SUBJECT: Addendum No. 2
Wentworth Springs Road at Gerle Creek – Bridge Replacement Project
Contract No. PW 11-30573, CIP No. 77118

WENTWORTH SPRINGS ROAD
at GERLE CREEK
BRIDGE REPLACEMENT PROJECT

SHEET
S-1
6 OF 13
W.O. No. 77118

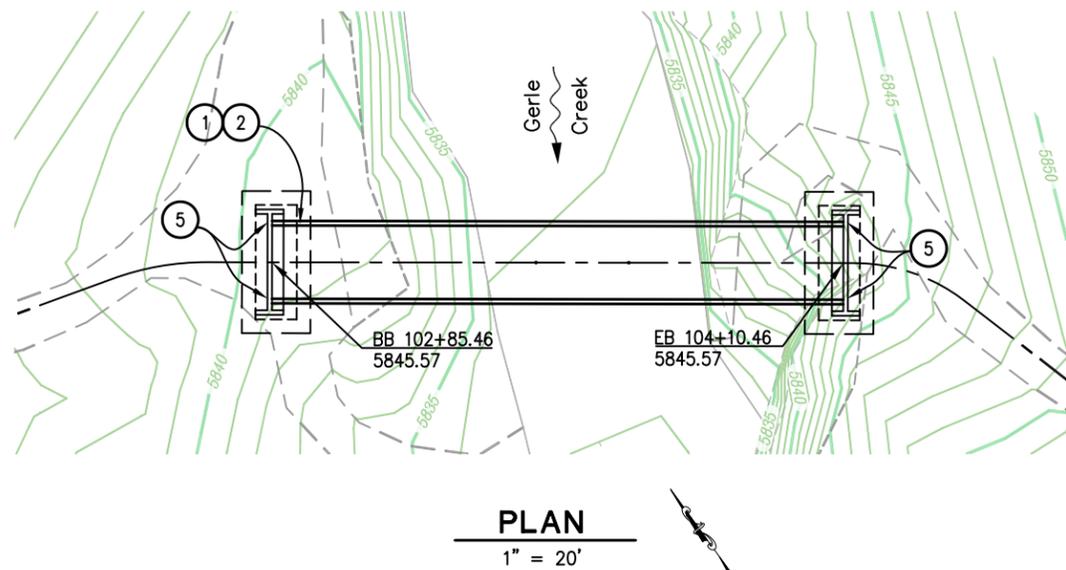
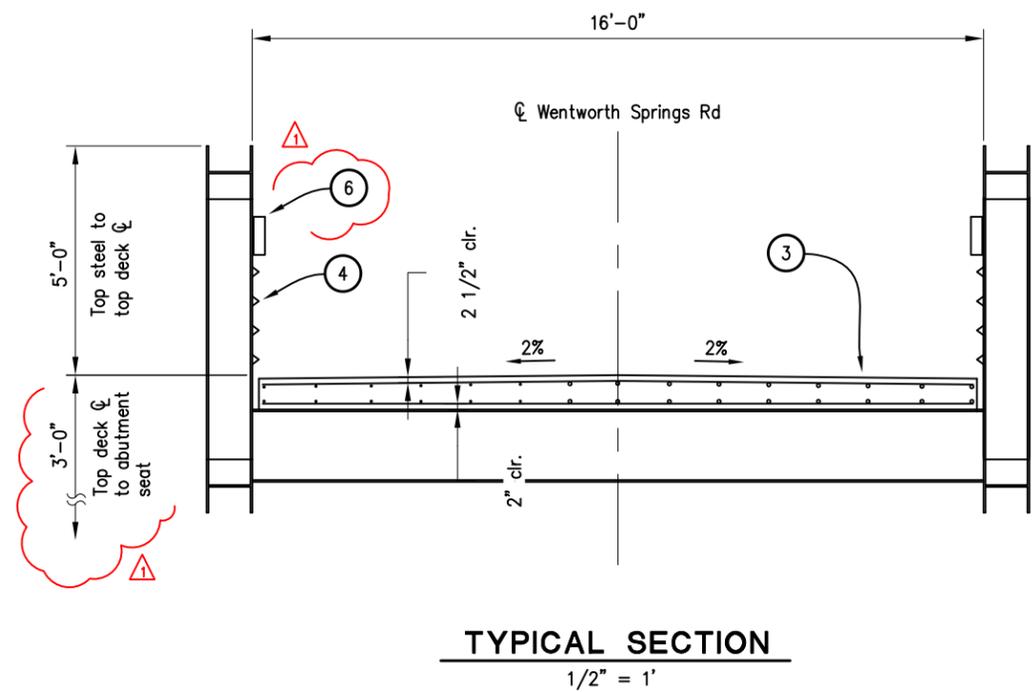
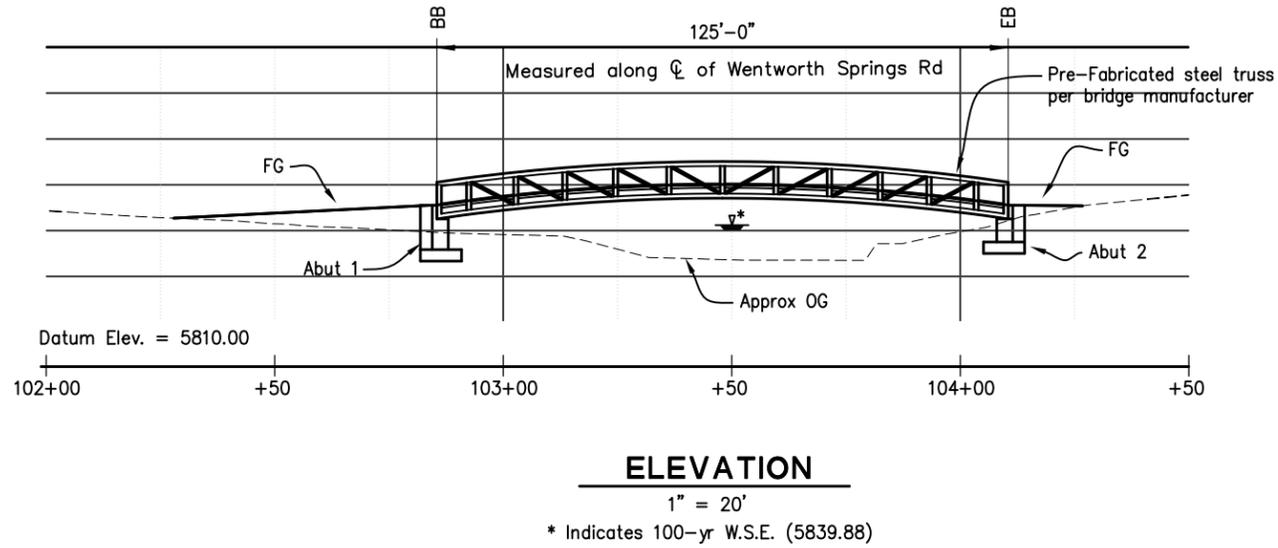
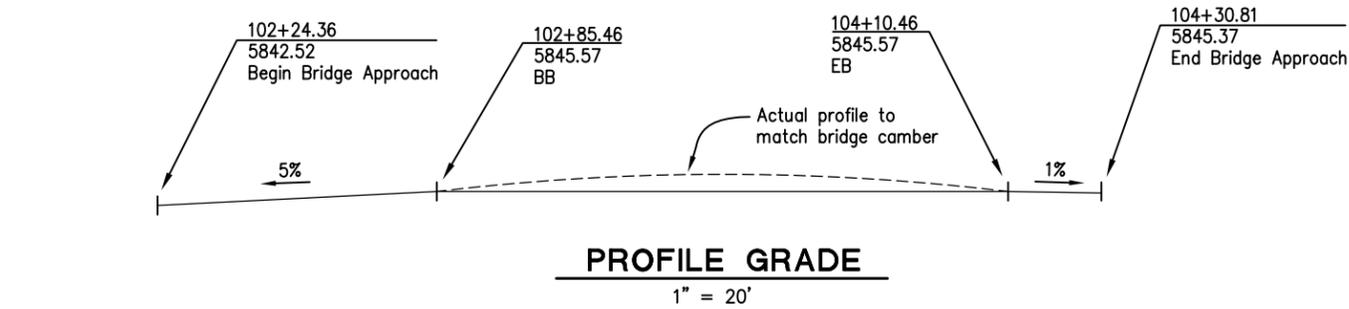
2.02	Plan Sheet S-1	Questions: An 8ft truss height will be difficult to design for the loads and meet the 400k maximum dead load reaction. Is a taller truss allowed as long as the 3'-0" low steel is held? Answer: The County will accept designs for a taller truss as long as the low steel dimension is maintained in accordance with 2.02 of this Addendum and the design reactions are not exceeded.

2.03	Plan Sheets S-1 and S-5	Questions: The project specifications limit the abutment backwall height to 3'-0" while the drawings show a 3'-0" top of deck to low steel dimension. Answer: Bidders are instructed to replace Plan Sheet 6 of 13 (S-1) with revised Plan Sheet 6 of 13 (S-1) attached to this Addendum.

2.04	Plan Sheet S-1 and SP-75	Question: Are there going to be any vehicular rail requirements on this bridge structure? While CALTRANS style barriers are likely not required on a structure of this type, we would normally recommend some type of more substantial railing element between the roadway and truss (potentially a

<p>10" high tubular or HSS member), in addition to the angle safety rails, and designed for some lateral impact load (say 10 kips).</p> <p>Answer: Bidders are instructed to replace Plan Sheet 6 of 13 (S-1) with revised Plan Sheet 6 of 13 (S-1) attached to this Addendum.</p> <p>Add the following after last sentence of 2nd to last paragraph on SP-75 of Section 10-1.19 "Pre-fabricated Steel Truss Bridge":</p> <p><i>"A guard railing made of hollow structural steel and measuring 10-inches in depth shall be installed approximately 40-inches above the top of deck on the inside of both trusses. The railing shall be designed to withstand a horizontal impact load of 10 kips."</i></p>

REVISION	NUMBER	DATE	DESCRIPTION	BY
△	4/4/12		REVISED LOWER TRUSS DIMENSION CALL-OUT; ADDED GUARD RAILING.
